CONSTRUCTION PLANS
FOR
THE RIDGE AT LORSON RANCH FILING NO. 1
STREET & STORM SEWER CONSTRUCTION PLANS

THE RIDGE AT LORSON RANCH FILING NO. 1
STREET / STORM SEWER
CONSTRUCTION PLANS

DATE: MARCH, 2022
PROJECT NO. 100.066
SHEET NUMBER C1.1
TOTAL SHEETS: 51

STM LAT "F" PROFILE

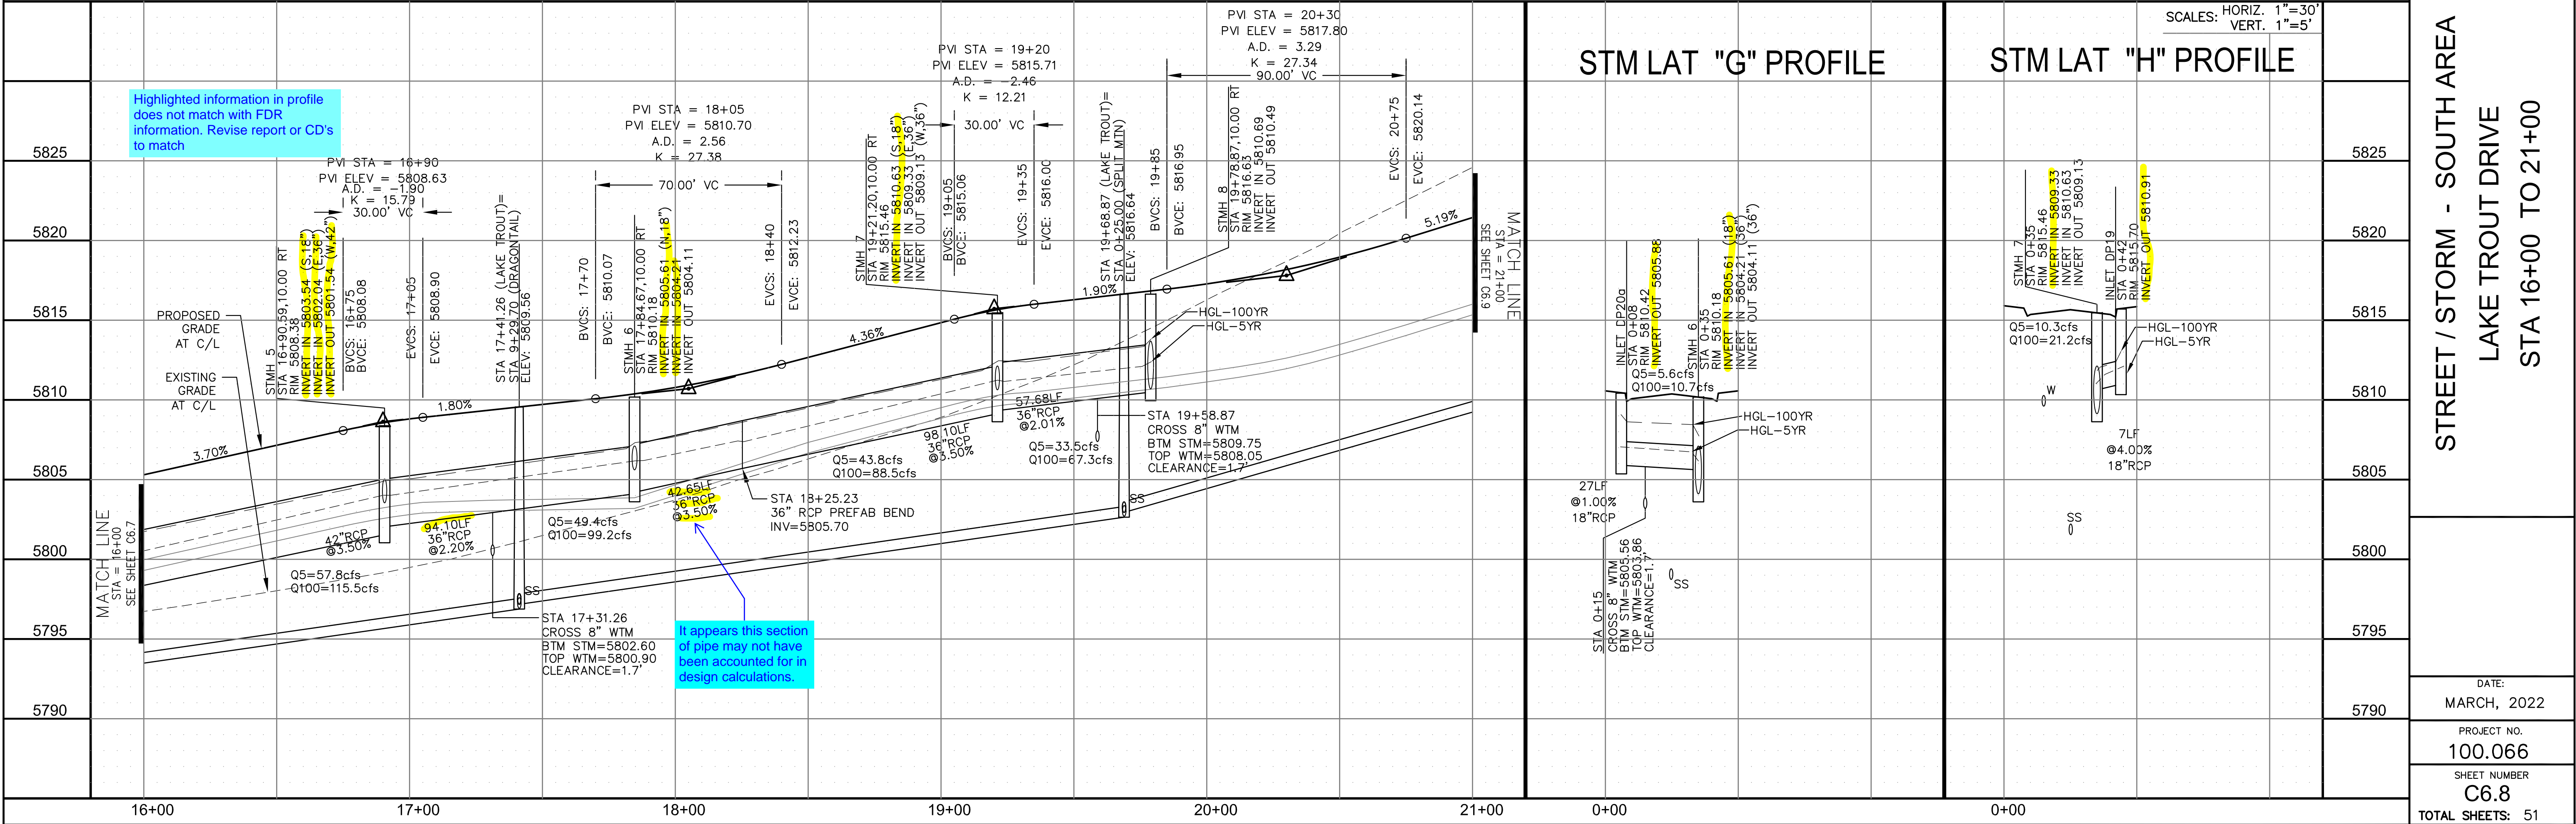
Highlighted information in profile does not match with FDR information. Revise report or CD's to match

SHEET NUMBER
 C6.10

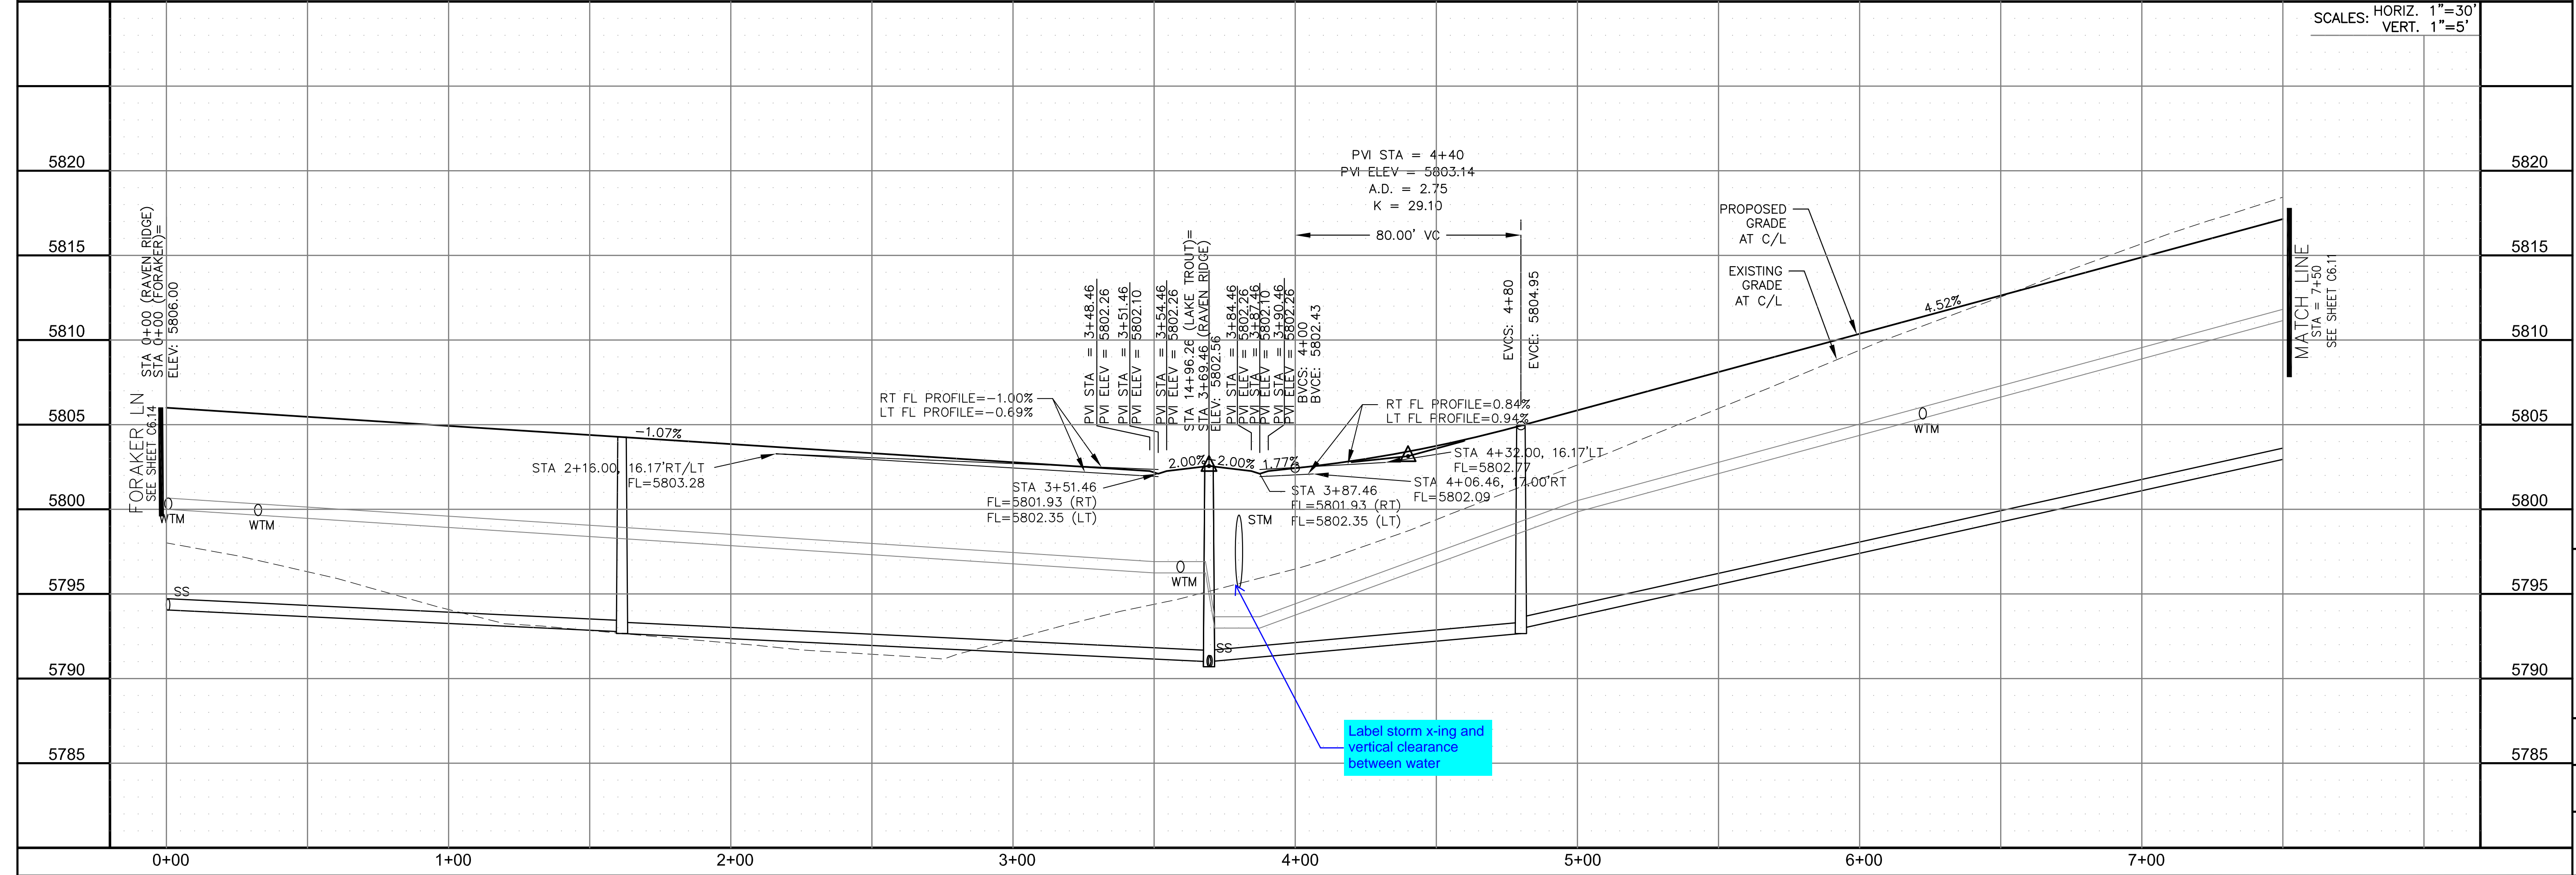
Label storm x-ing and vertical clearance between water

STM LAT "K" PROFILE

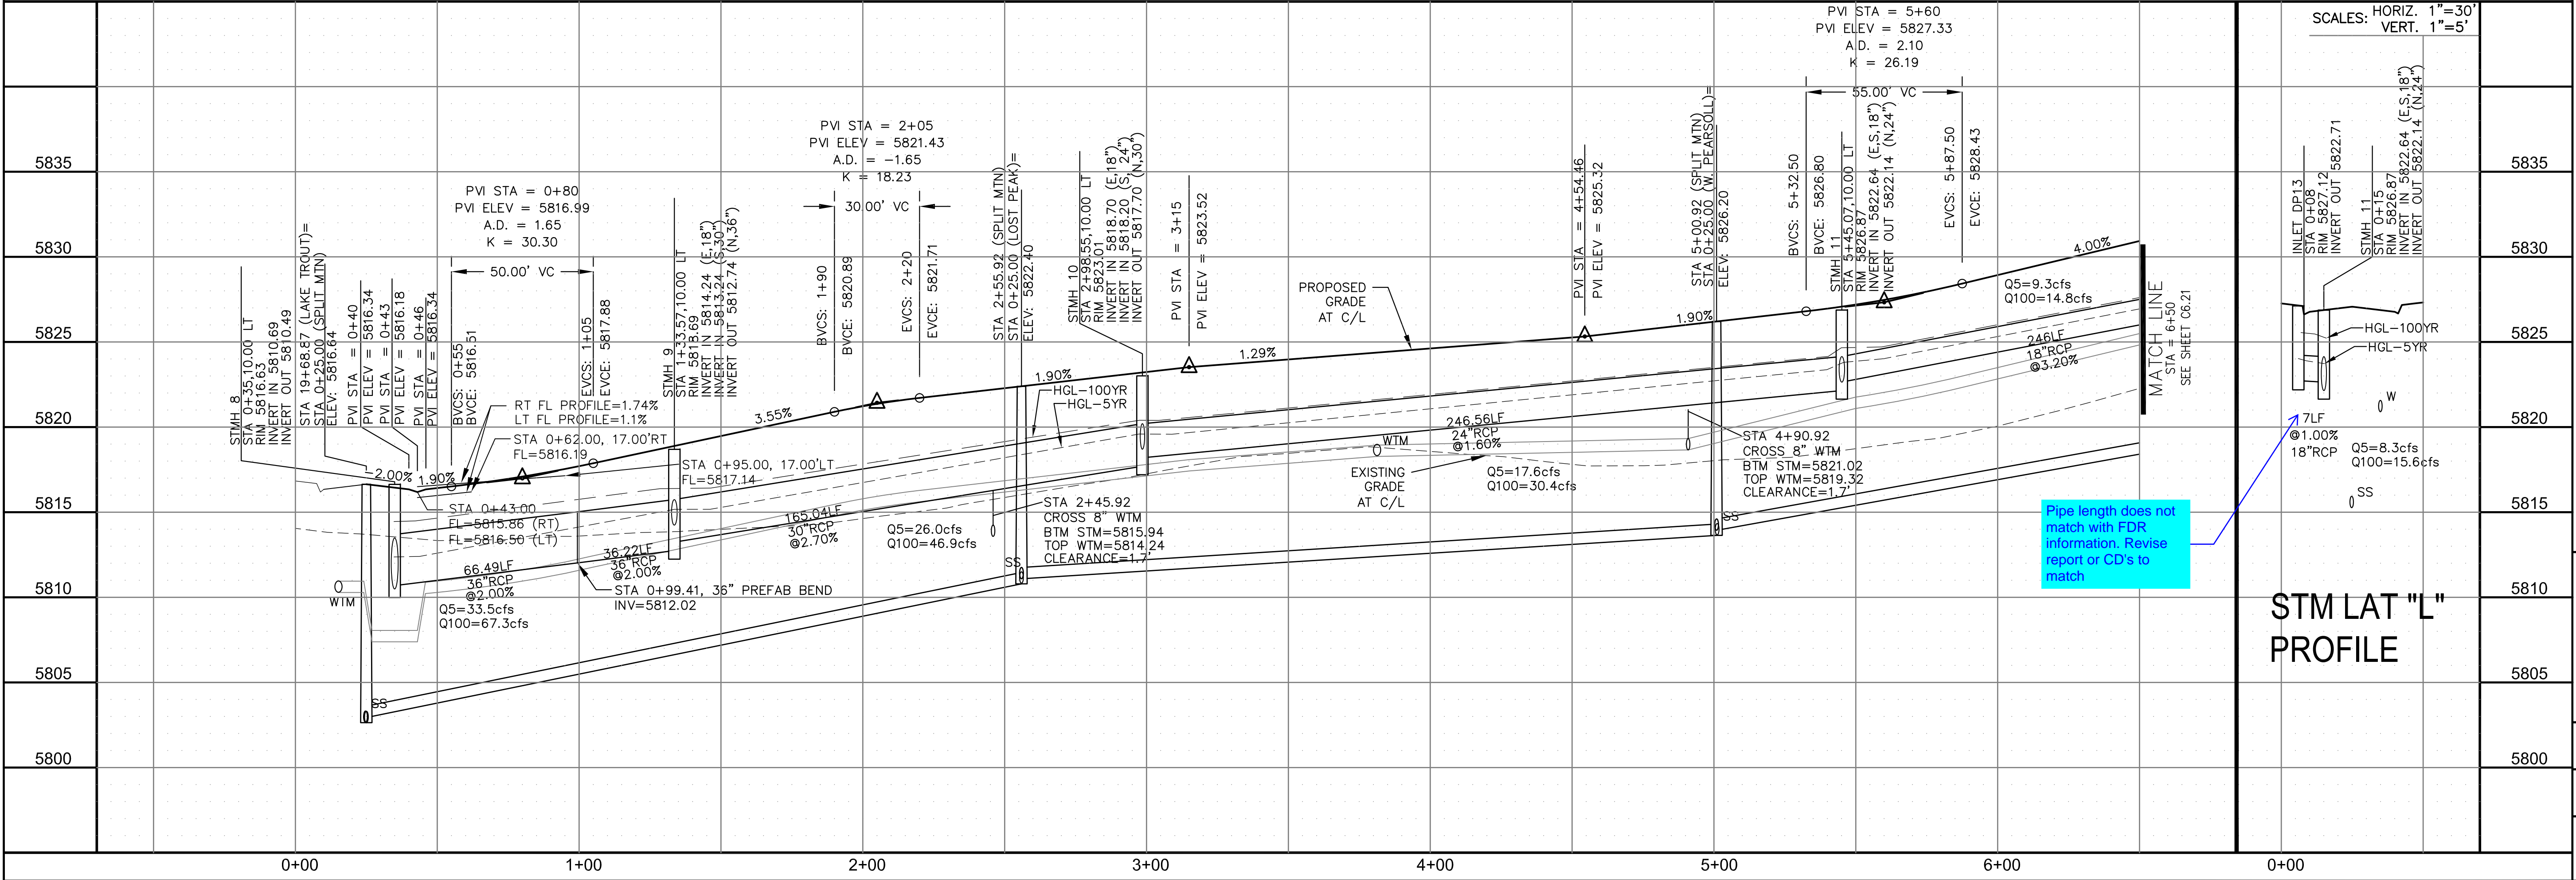
Pipe length does not match with FDR information. Revise report or CD's to match

SHEET NUMBER
C7.1

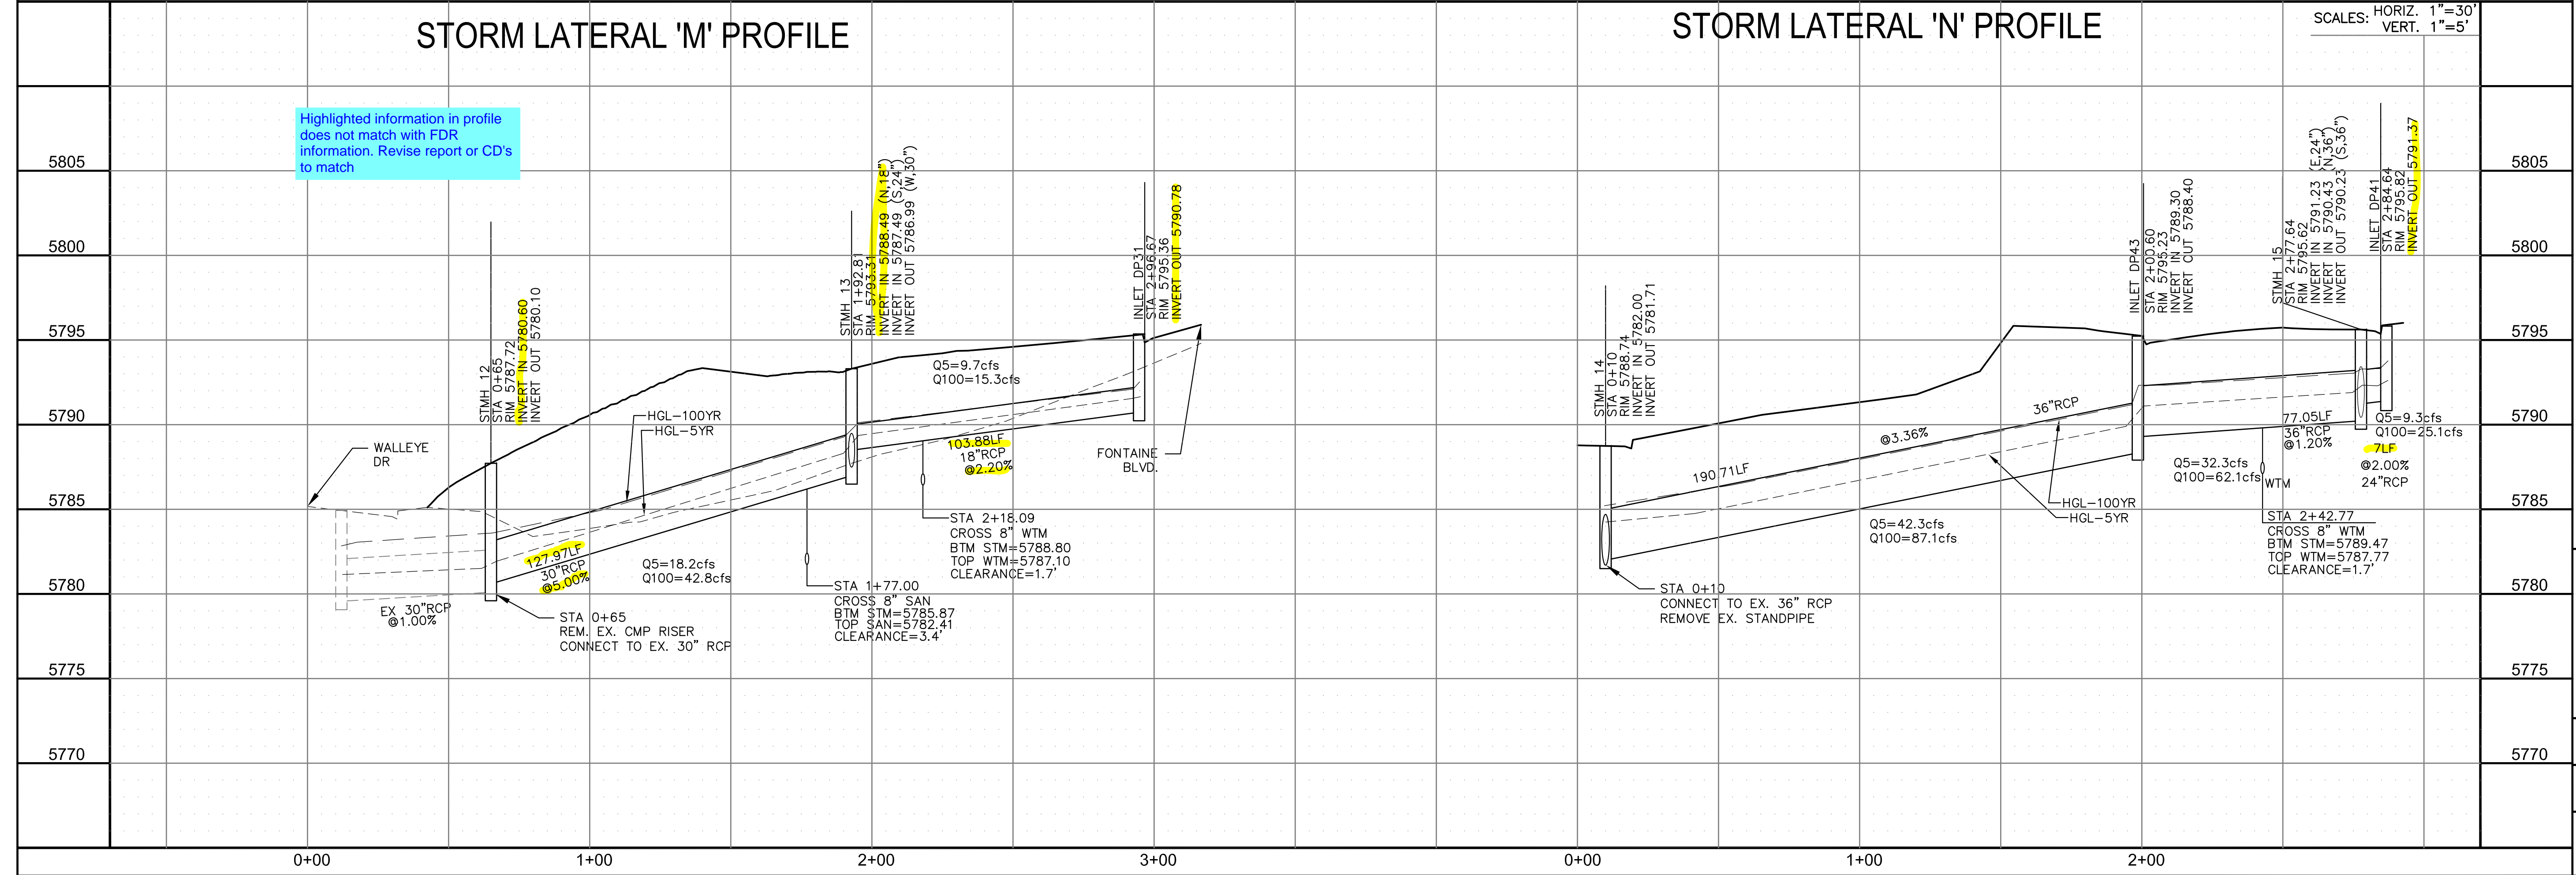
Highlighted information in profile does not match with FDR information. Revise report or CD's to match
